**PLANNING COMMISSION SITE PLAN
EXTENSION REVIEW SHEET**

<u>CASE NUMBER:</u>	SP-2013-0026C(XT2)	<u>PC HEARING DATE:</u>	November 12, 2019
<u>PROJECT NAME:</u>	Grove Retail Center		
<u>ADDRESS OF SITE:</u>	5900 E Riverside Drive	<u>COUNCIL DISTRICT:</u>	3
<u>WATERSHED:</u>	Country Club East (Suburban)	<u>JURISDICTION:</u>	Full Purpose
<u>APPLICANT/ OWNERS:</u>	Self Directed IRA Services, Inc. Custodian FBO David Beseda IRA 600 Congress Avenue, Ste. 400 Austin, TX 78701		(512) 971-1616
<u>AGENT:</u>	Mirza Baig, PSCE, Inc. 2205 W Parmer Lane, Ste. 201 Austin, TX 78727		(512) 238-6422
<u>CASE MANAGER:</u>	Anaiah Johnson Anaiah.Johnson@austintexas.gov		(512) 974-2932

CITY OF AUSTIN – DEVELOPMENT SERVICES DEPARTMENT
SITE PLAN APPLICATION – MASTER COMMENT REPORT

CASE NUMBER: SP-2013-0026C(XT2)
REVISION #: 00
CASE MANAGER: Anaiah Johnson
UPDATE: U3
PHONE #: 512-974-2932

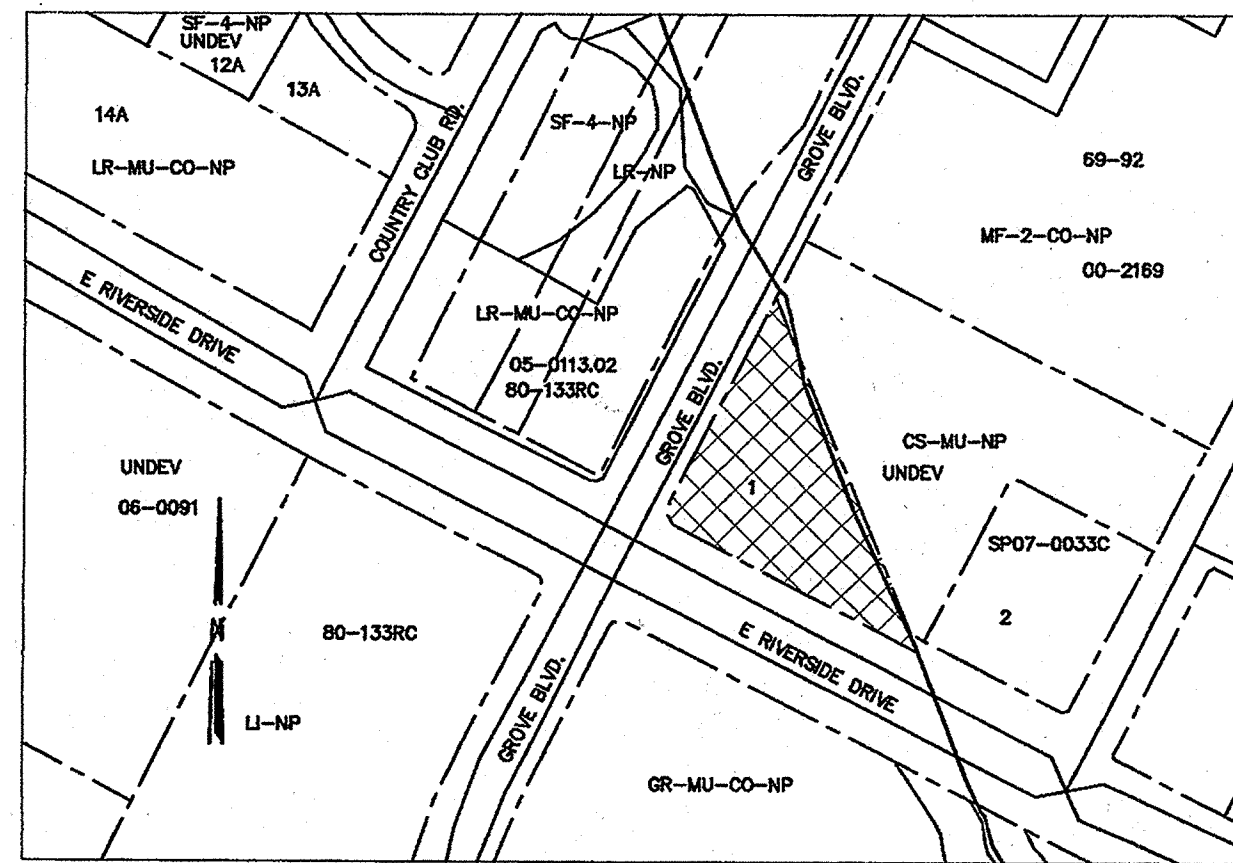
TR6. Riverside Drive is a core transit corridor and requires approved shade street trees to be planted at an average spacing no greater than 30 feet on center. Please clarify if a license agreement was recorded with the original and/or revised site plan application. It does not appear that the shade street trees are proposed on the landscape sheet. The license agreement may need to be revised for the Corridor Mobility Program improvements.

U3: Comment not cleared. Per the applicant, a license agreement was not approved with the original application and a license agreement is not in review. The required street trees along Riverside Drive have been proposed to be located within the property along instead of within the planting zone; therefore, the applicant has requested AEC. Please submit the AEC letter for review and

approval. The following is required as a condition of the extension approval and are pending a correction or revision:

- 1. AEC approval with the associated notes and callouts on the plans.**
- 2. Dimension the tree spacing on the landscape sheet.**
- 3. Certain CPO and bicycle facility improvements within the ROW (pavers and terra-cotta colored concrete) require a license agreement. A license agreement will be required based on the required improvements as a condition of the extension.**
